OPTIONAL SERVICE BULLETIN

OSB 42NG-027/1

I.5 Subject

Heating inlet using ram air.
ATA-Code: 21-40

Template

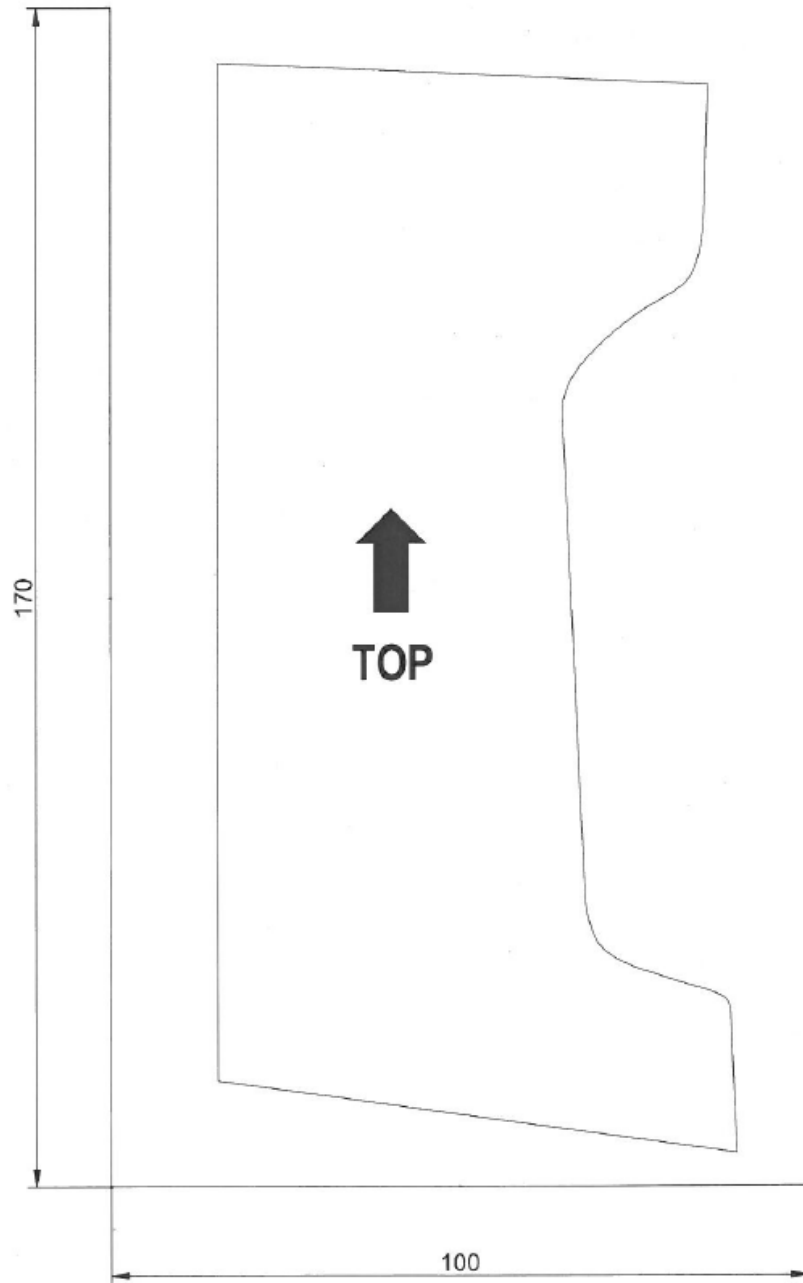
- Remove lower cowlings, refer to AMM Chapter 71-10.
- Trim heat exchanger box per template attached.
